Wollongong Local Planning Panel Assessment Report | 20 October 2020

WLPP No.	Item 1
DA No.	DA-2020/241
Proposal	Residential - demolition of existing structures and construction of a seven (7) storey residential flat building comprising of 40 units and one (1) level basement car parking
Property	93 - 99 Kembla Street, WOLLONGONG
Applicant	ADM Architects
Responsible Team	Development Assessment and Certification - City Centre Team (NL)

ASSESSMENT REPORT AND RECOMMENDATION

Figure 2: DA-2018/803 (14 Beatson St)

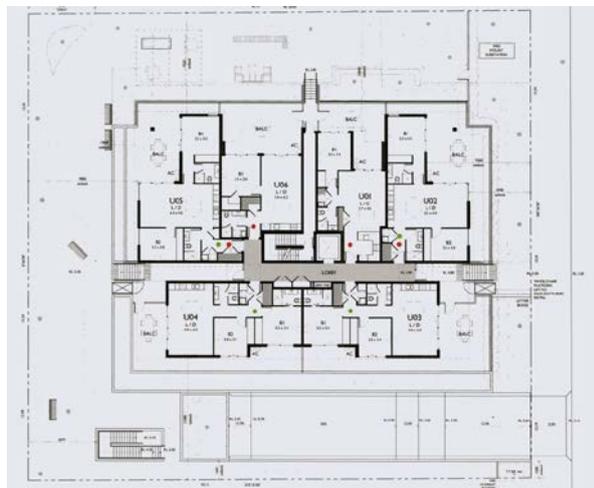
While there is an example opposite the site of poor execution of the communal open space and public domain elements, there are also other examples on Beatson Street (see below) where such compromised outcomes have not resulted from similar design.

Title
DEVELOPMENT APPLICATION BASEMENT FLOOR PLAN

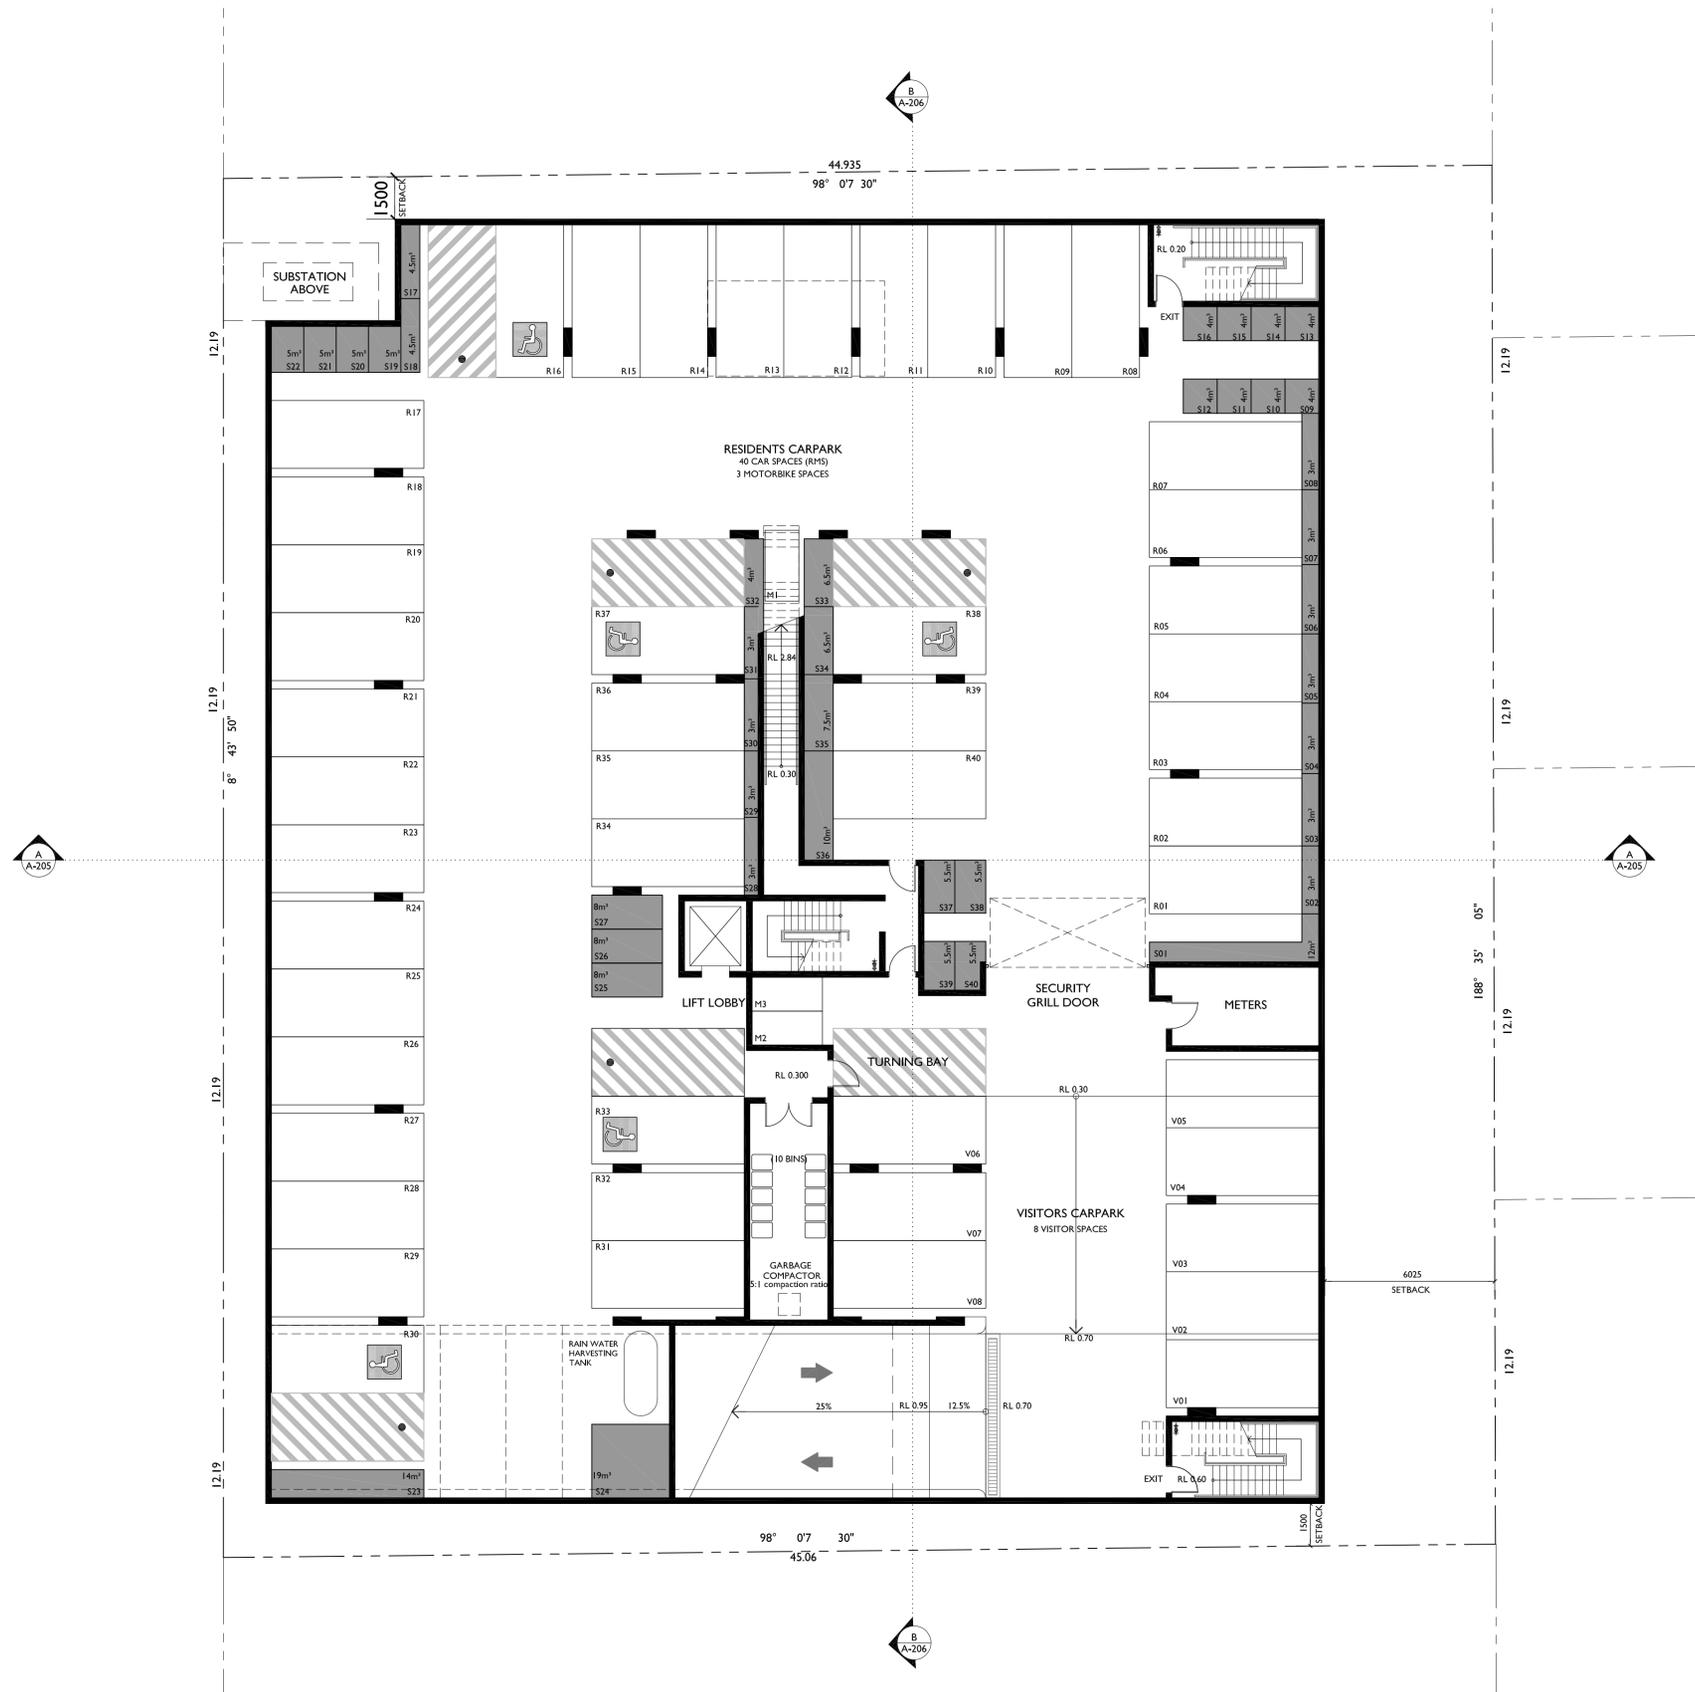
Response: Storage areas within units are clearly identified (by shading) on the floor plans prepared by ADM Architects. Within the basement, the previously proposed over bonnet storage areas have been removed due to a reduction in basement size. Individual storage areas for each unit and now provided throughout the basement, with these areas numbered and the capacity indicated on Drawing A – 101 prepared by ADM Architects.
